SUBJECT: Forwards addl info on proposed license amend re boric acid concentration reduction, per NRC 880310 request.

Re: St. Lucie Unit 1  
Docket No. 50-335  
Request for Additional Information -  
Boric Acid Concentration Reduction

ST. LUCIE UNIT 1  
BORIC ACID CONCENTRATION REDUCTION

FPL RESPONSE TO NRC REQUEST FOR ADDITIONAL INFORMATION

REACTOR AUXILIARY  
 BUILDING-SECTIONS  
 FIGURE 2

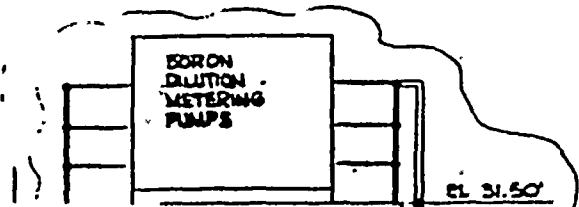
In regards to the surveillance required when the Reactor Auxiliary Building air temperature is less than 55 F and considering the physical size of the multi-level building, please discuss the location(s) where the air temperature(s) will be taken and the relationship between the location(s) and the location(s) of all components of the BAMU system.

pipng, and piping to the suction of the charging pumps) are located in relatively close proximity on the minus 0.5 ft. elevation of the Reactor Auxiliary Building. The exception is the boric acid makeup tanks, which have tank tops at elevation 32.75 ft. as shown on Figure 2.

# FIGURE 3.1-1 ST. LUCIE 1 MIN BMT VOLUME

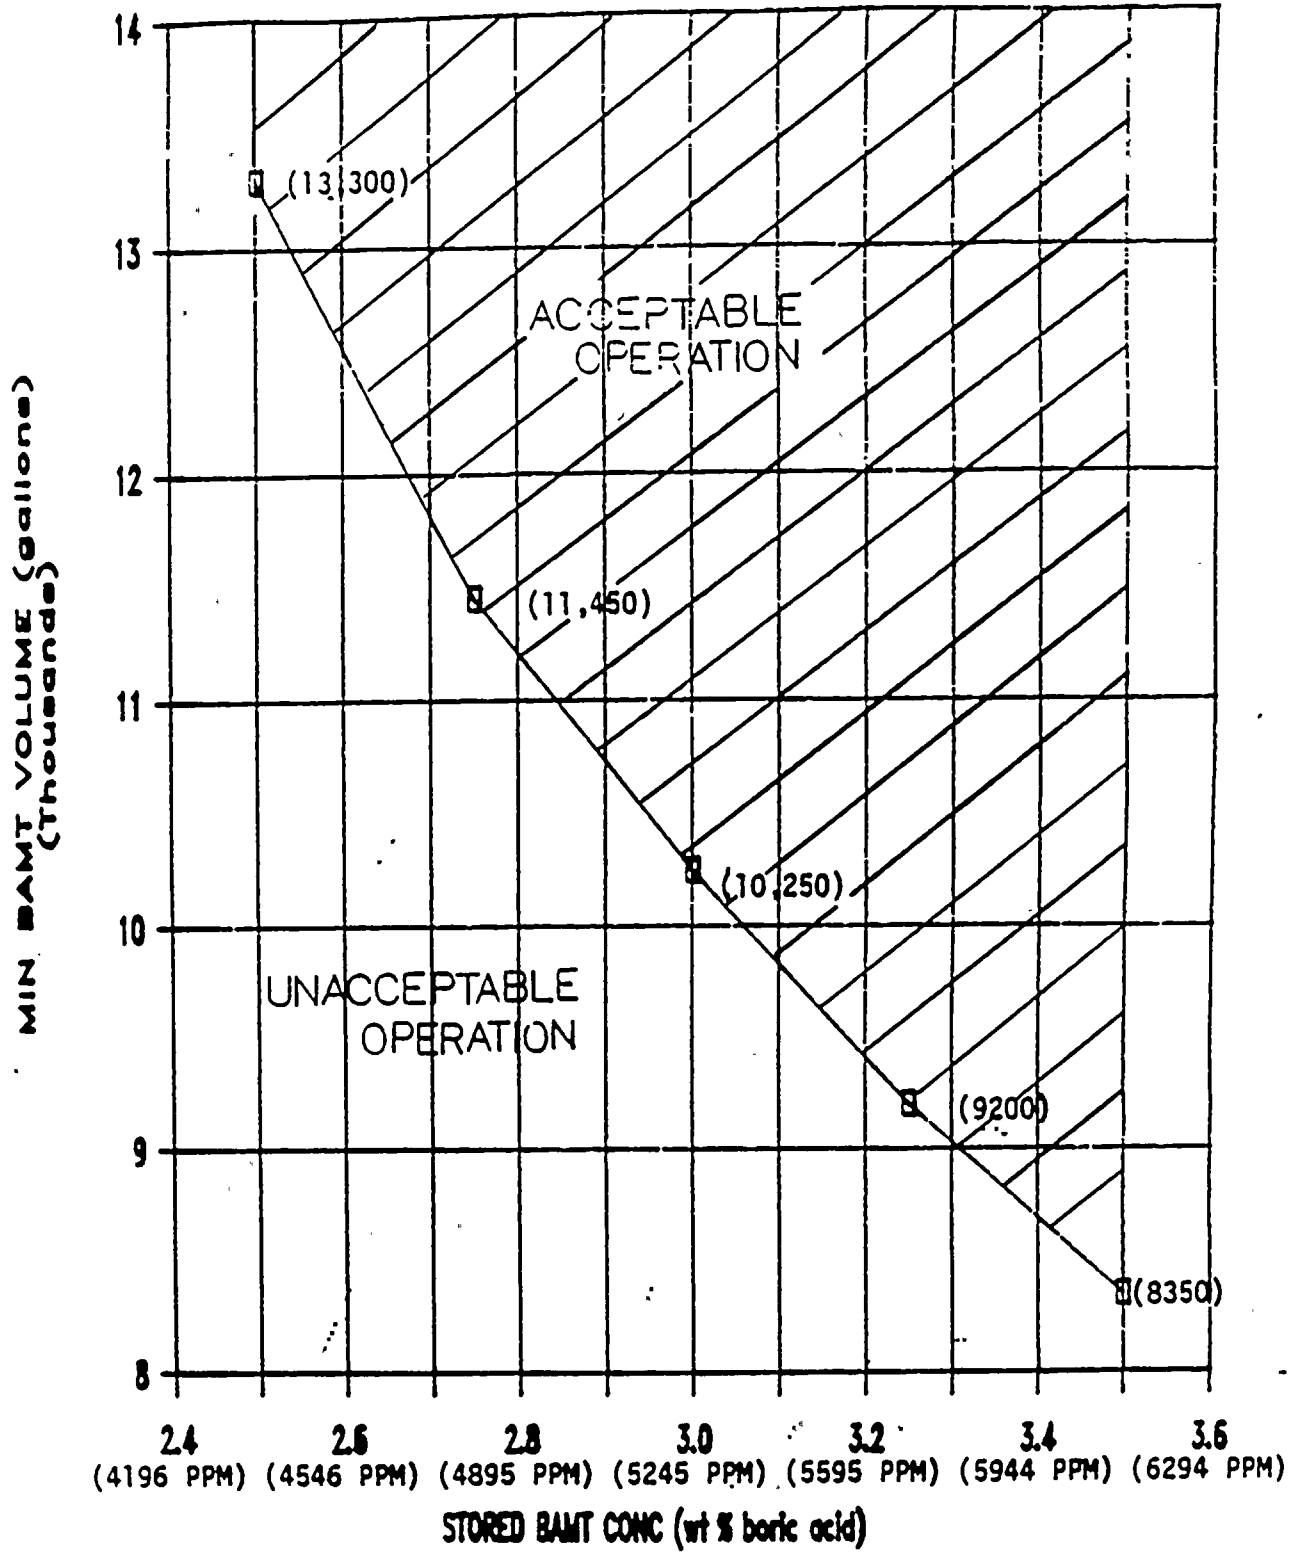
In regard to proposed Figure 3.1-1, please explain why it is necessary to have at the bottom of the figure the expression "1720 ppm in the RWT."

We have reviewed Figure 3.1-1 and have determined that the expression "1720 ppm in the RWT" at the bottom of the figure is not necessary. Therefore, we propose to remove this expression (See attached revised Figure 3.1-1).
